## ADDENDUM THREE

Ivy Flats  
205 Rumely Street  
LaPorte, IN 46350

Commission No.: F22131

Addendum Date: 29 April 2024

A401

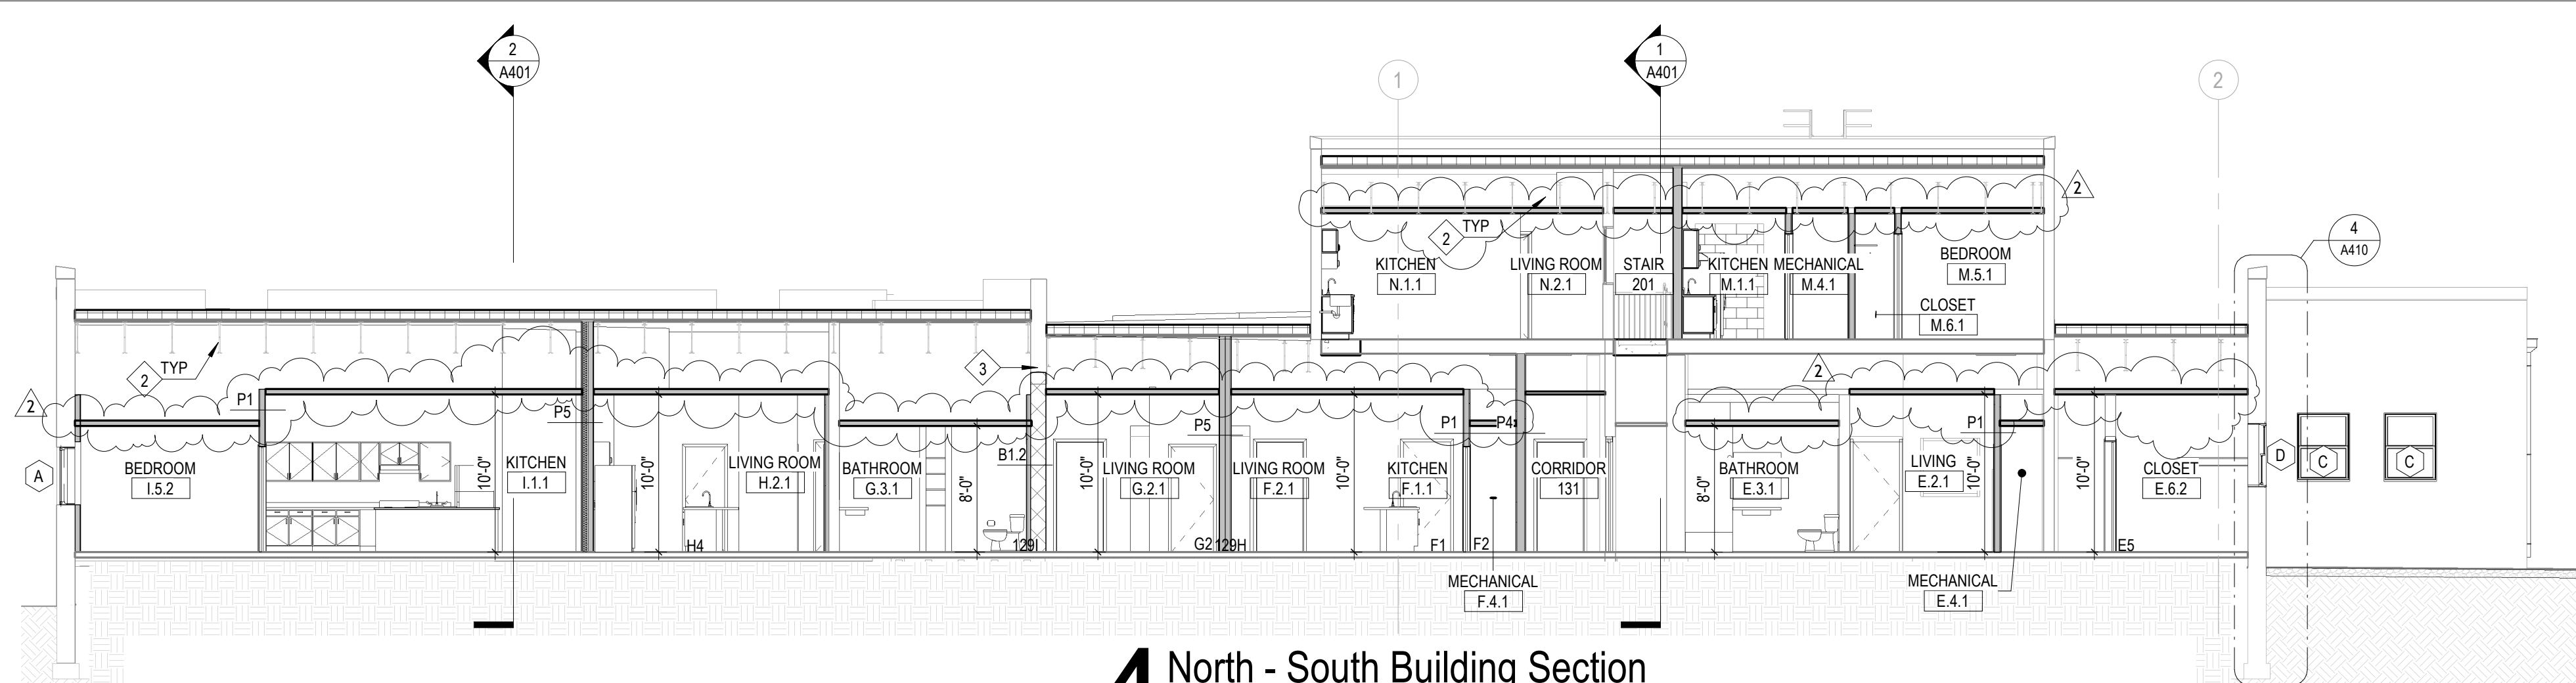
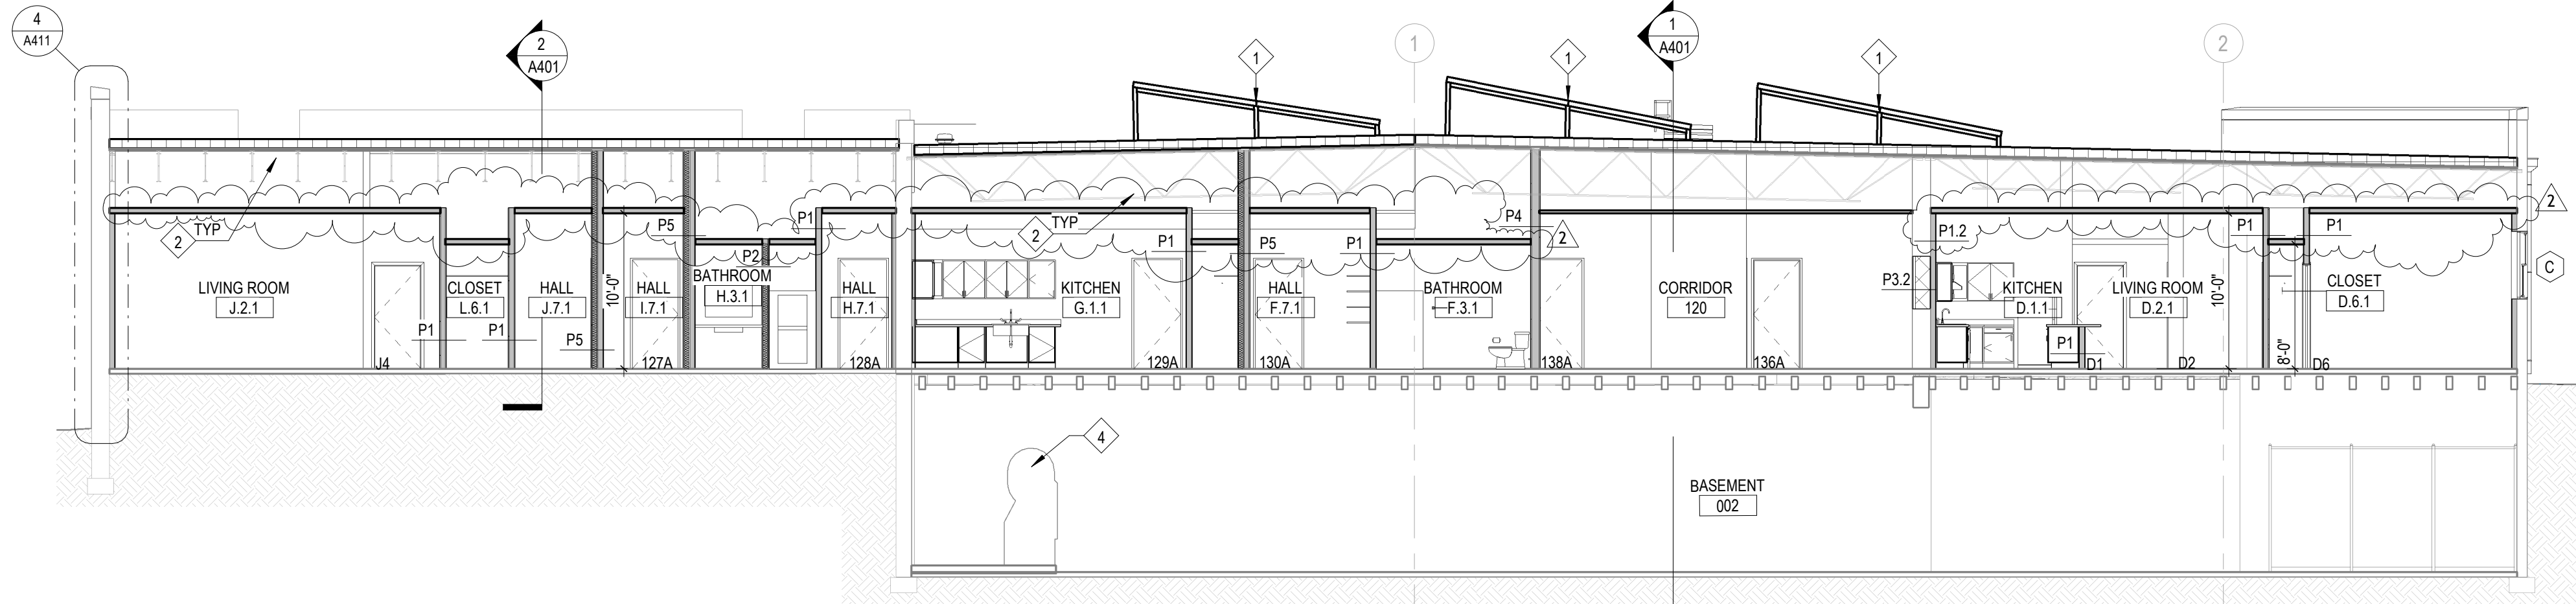
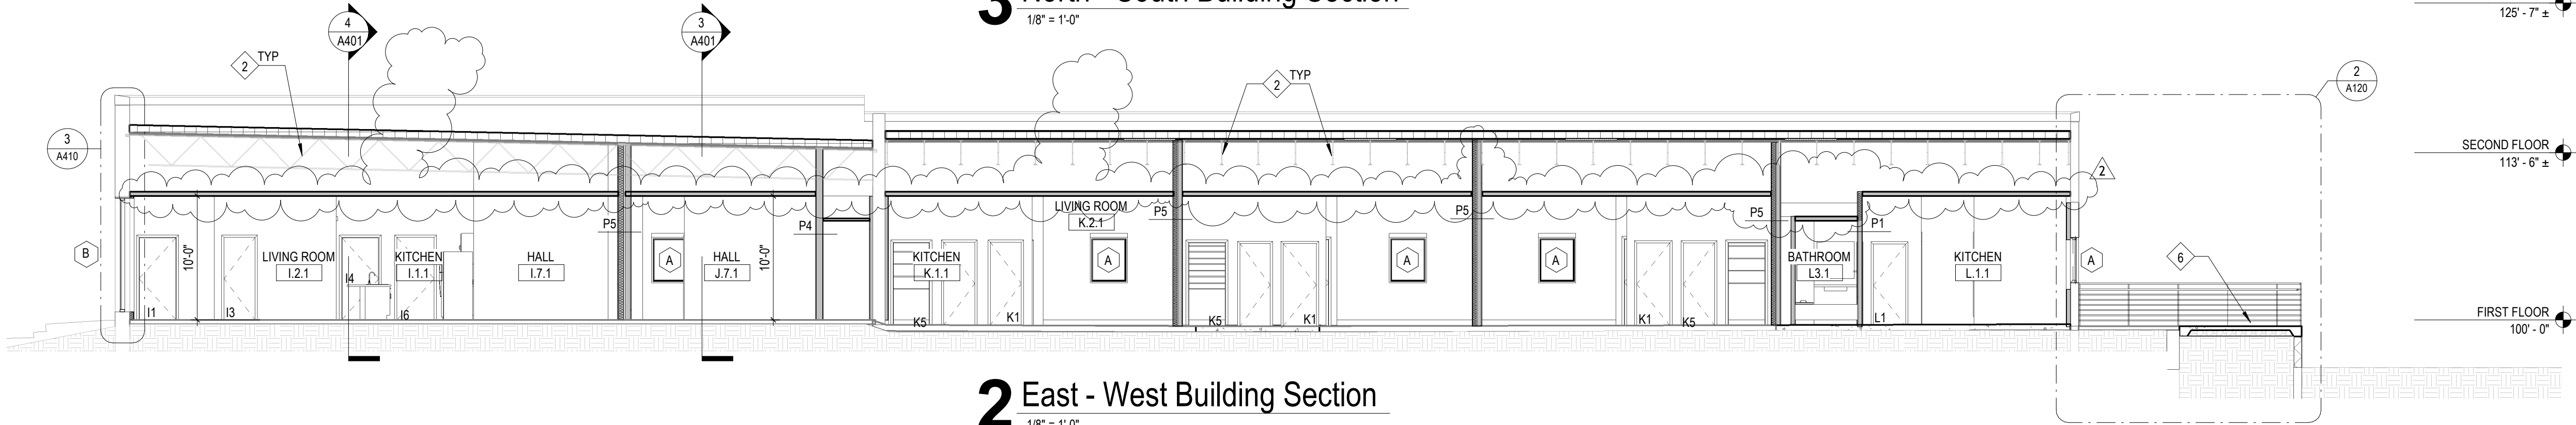
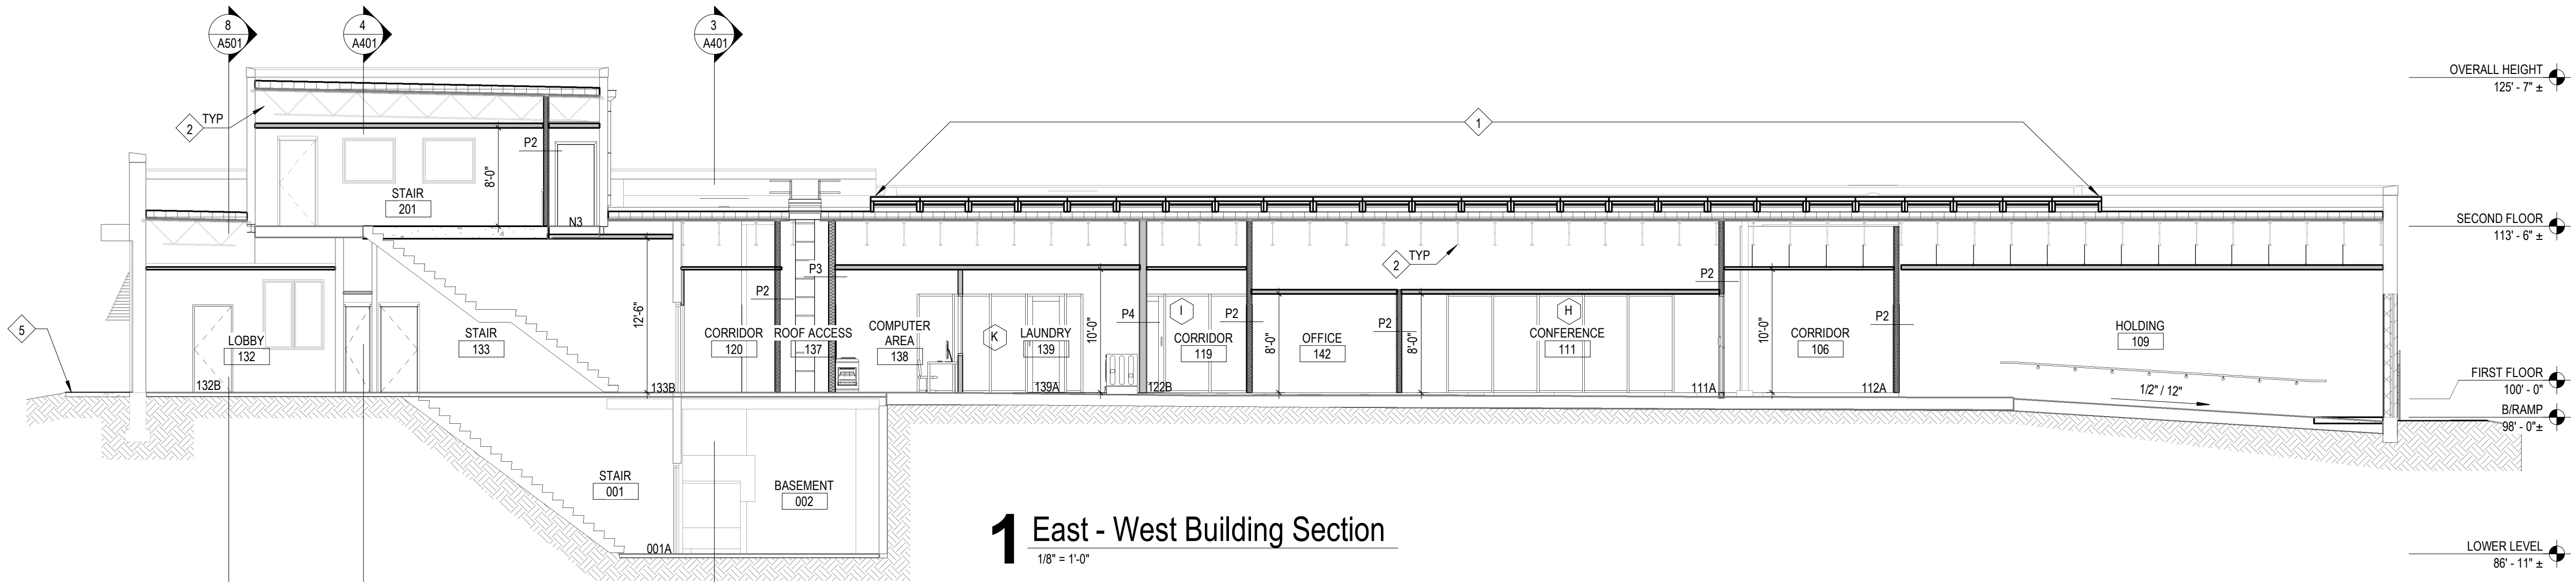
- WORK DESCRIPTION NOTES: **REMOVE** Note #7 in entirety.
- 2/A401: **REMOVE** all insulation above Units (R-13).
- 3/A401: **REMOVE** all insulation above Units (R-13).
- 4/A401: **REMOVE** all insulation above Units (R-13).

**11** Storefront K  
1/4" = 1'-0"

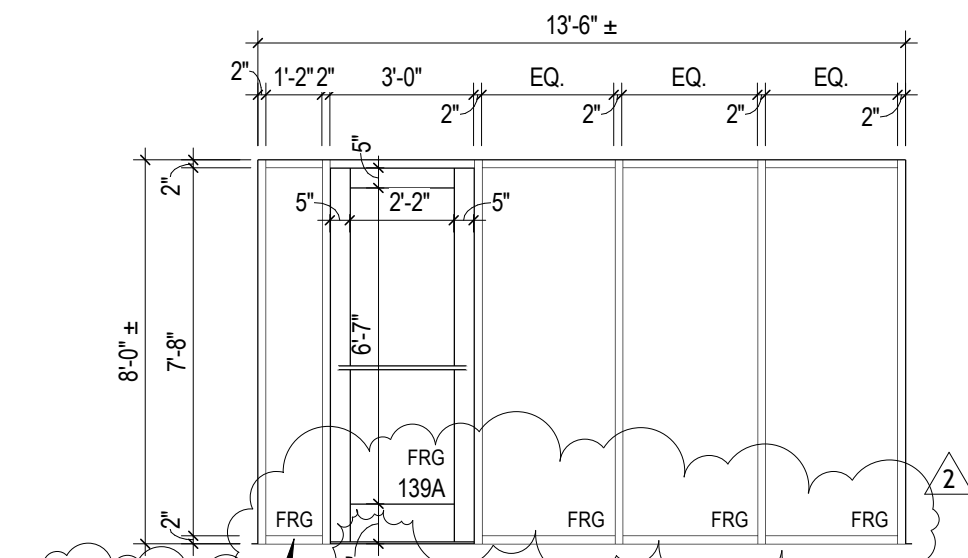
- 11/A512:
  - **ADD** Description Note stating, "FIRE RESISTANT FRAMING SYSTEM".
  - **UPDATE** Glazing Type to 'FRG' (five panels, including door).
- 21/A512:

**10** Storefront J  
1/4" = 1'-0"

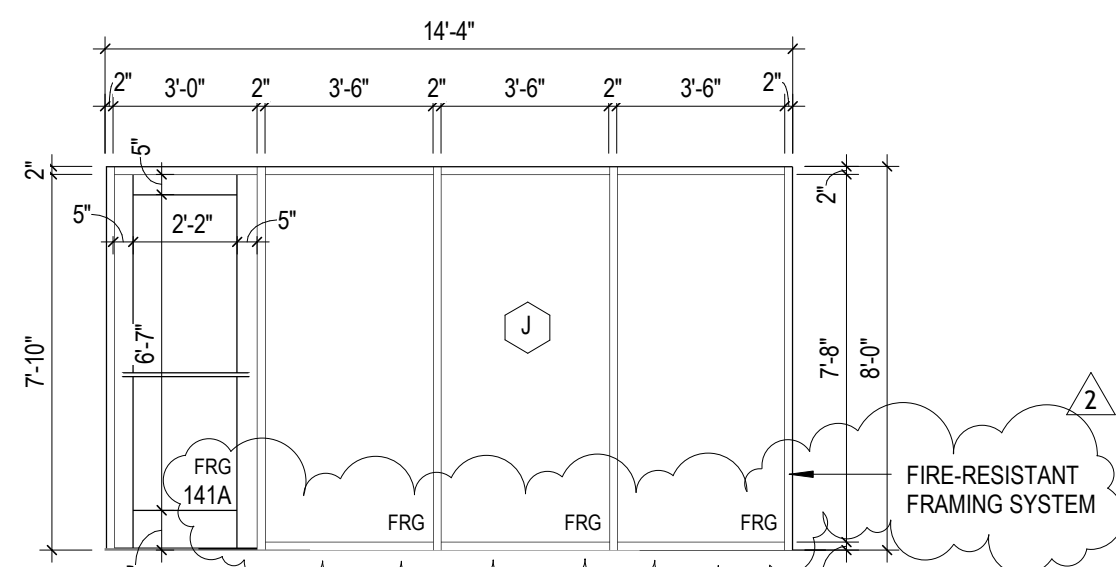
- **UPDATE** Glazing Type to 'FRG' (five panels, including door).
- 10/A512:
  - **ADD** Description Note stating, "FIRE RESISTANT FRAMING SYSTEM".
  - **UPDATE** Glazing Type to 'FRG' (four panels, including door).

**8** Storefront H  
1/4" = 1'-0"

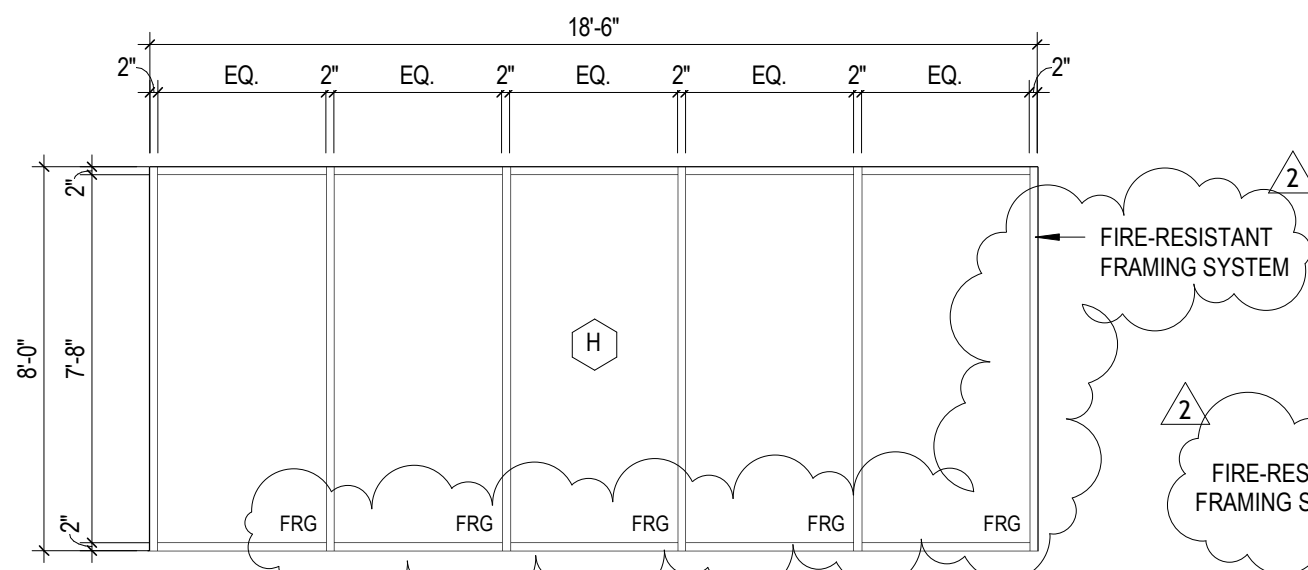
- **ADD** Description Note stating, "FIRE RESISTANT FRAMING SYSTEM".
  - **UPDATE** Glazing Type to 'FRG' (five panels).
- 9/A512:
  - **ADD** Description Note stating, "FIRE RESISTANT FRAMING SYSTEM".

**7** Storefront G  
1/4" = 1'-0"

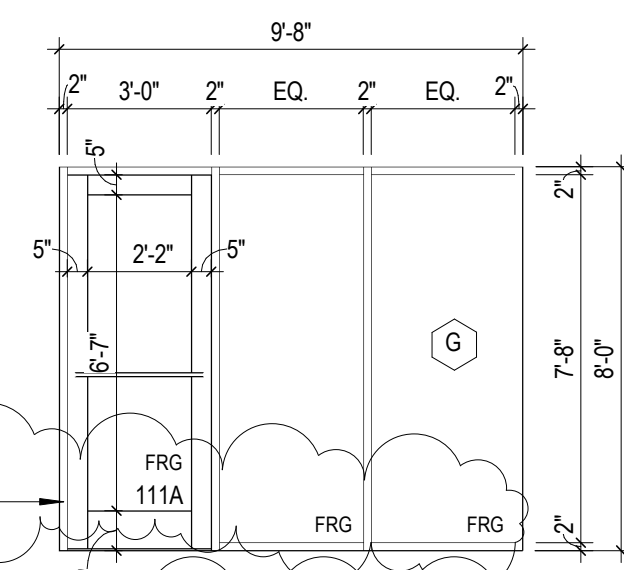
- 7/A512:
  - **ADD** Description Note stating, "FIRE RESISTANT FRAMING SYSTEM".
  - **UPDATE** Glazing Type to 'FRG' (three panels, including door).
- 8/A512:
